Randwick Local Planning Panel (Electronic) Meeting

Development Application Report No. D43/22

Subject: 6-10 Bowral Street, Kensington (DA/172/2022)

Proposal:	Demolition of the existing structures and the construction of a part six, part nine storey residential flat building with shared-way, basement parking and landscaping.
Ward:	West Ward
Applicant:	Mr D Dugandzic
Owner:	Mr D Dugandzic
Cost of works:	\$16,755,000
Reason for referral:	Height non-compliance >10%

Figure 4 – Active Street Frontages Map (RLEP)

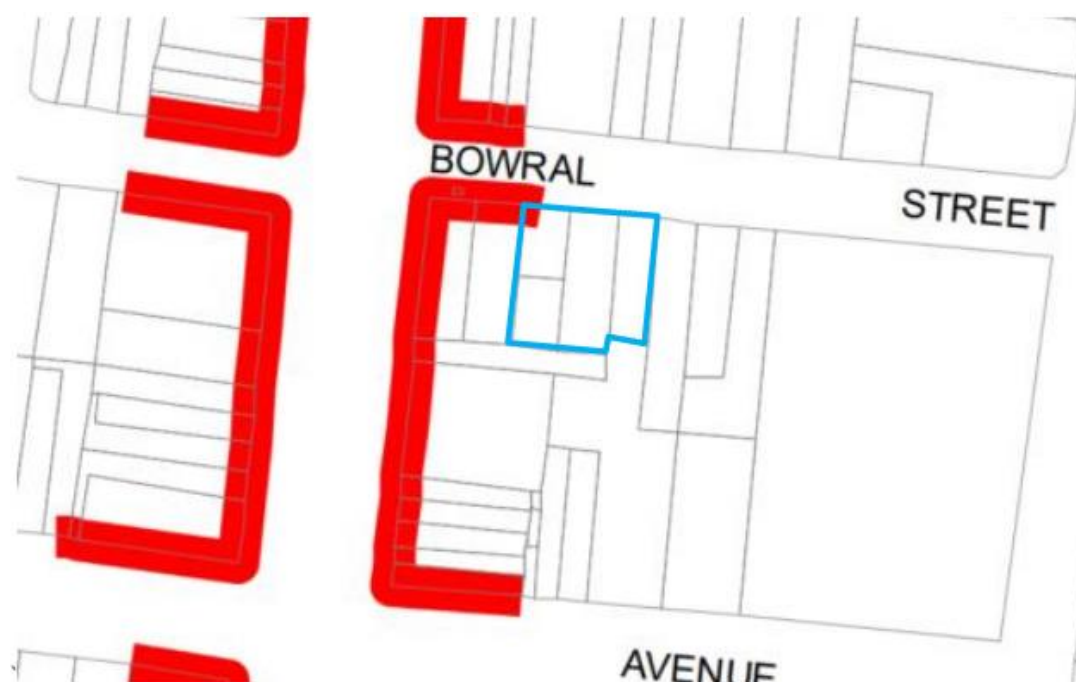
Clause 6.20 ‘Active Street Frontages at Kensington and Kingsford Town Centres’ of the RLEP applies to the corner of the allotment at 6 Bowral Street as shown in Figure 4 below.

Figure 24 Section indicating 7.5m wide area of non-compliance (blue), in comparison to the remaining built form (green)

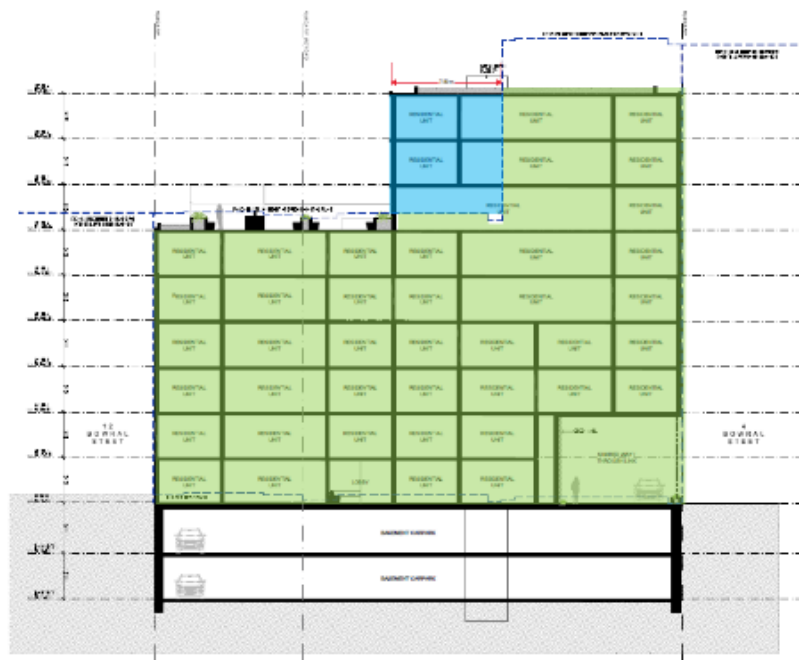
- The proposed built form substantially exceeds the maximum permissible building height under the RLEP. By extending the 9-storey component further east (against what is sought by the RLEP and K2K RDCP block diagram) the proposal fails to respond to the desired future character and does not provide sufficient transition to Kensington Public School and residential areas further east.

Figures 6– Block 28B (K2K RDCP)

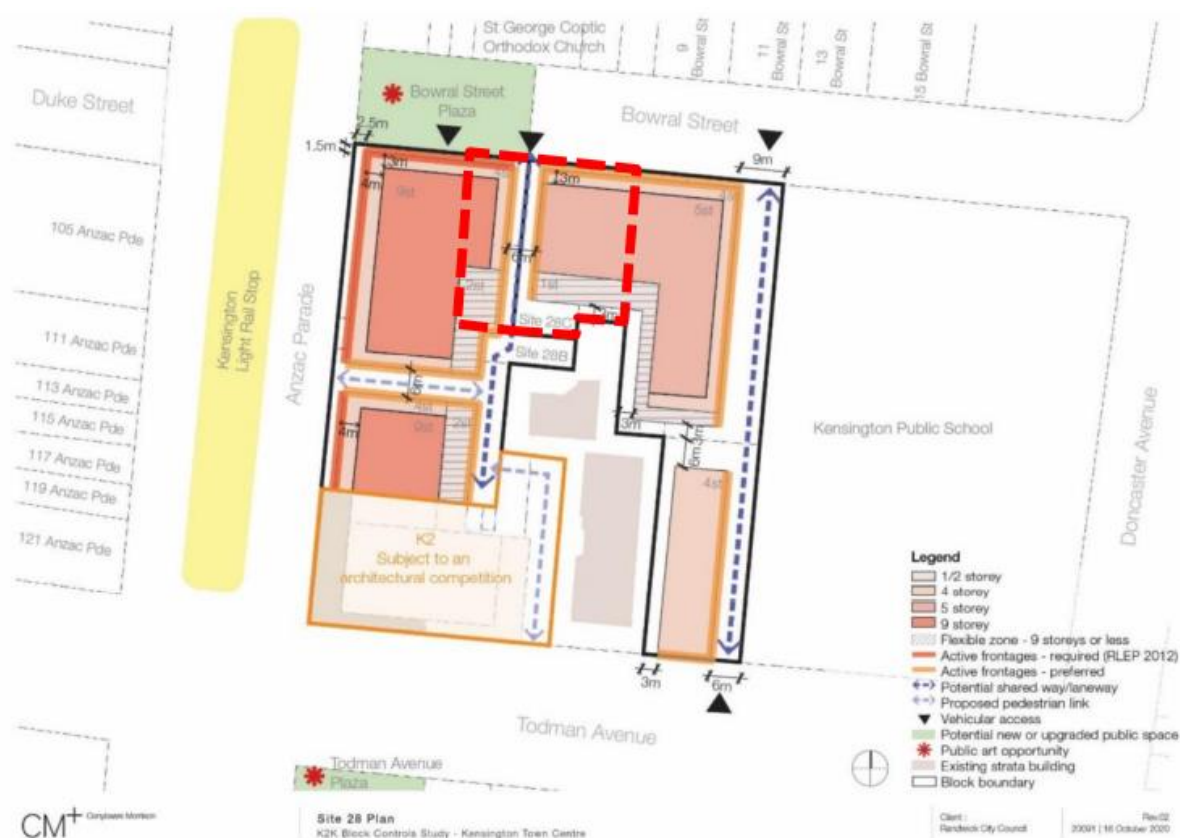
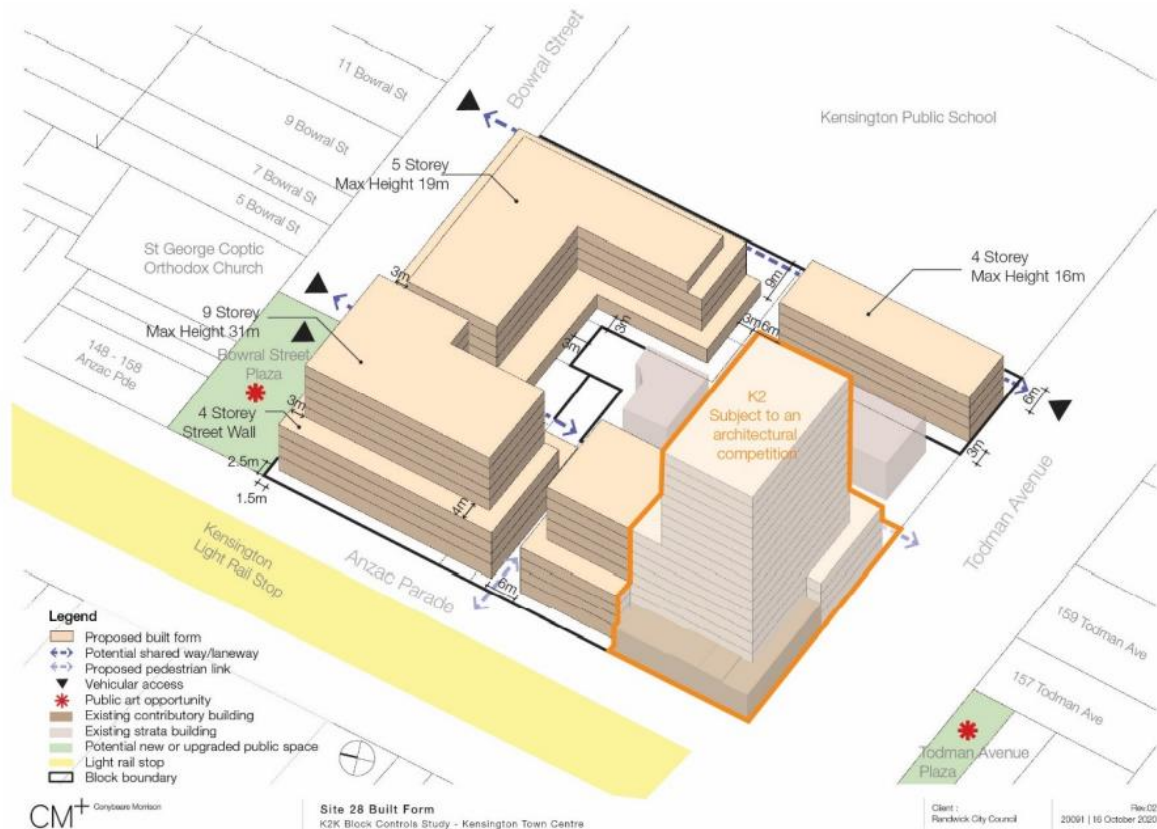
- c. Pursuant to Part 8 in the K2K RDCP, the proposal does not provide a laneway/shared zone in accordance with Block Diagrams 28B and 28C.
 - d. Pursuant to Part 9 in the K2K RDCP, the proposal results in adverse heritage impacts to the neighbouring item at Kensington Public School.

Section 10.3 in Part B of the K2K RDCP prescribes the desired future character and built form controls for Blocks 28B and 28C, in which the subject site is located. An extract of the Site Plan for Blocks 28B-C contained within the K2K RDCP is provided in Figures 6 and 7 below:

Figure 26 Active Street Frontages Map (Site edged in Blue)

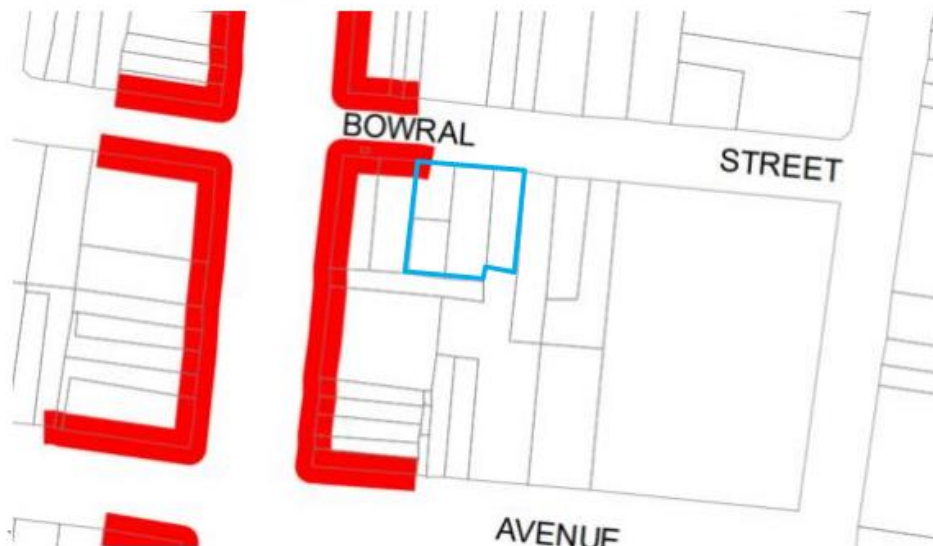
As such, Clause 6.20(3) applies to the subject site, specifically, a corner of the allotment identified as No. 6 Bowral Street, as reproduced in **Figure 26** below.

As demonstrated in **Figure 27** below, the subject site does not provide an active street frontage to the corner of the allotment (per the active street frontages map) within No. 6 Bowral Street. The corner of this site is proposed to be occupied by the shared-way and therefore the extent of variation sought is 100%.
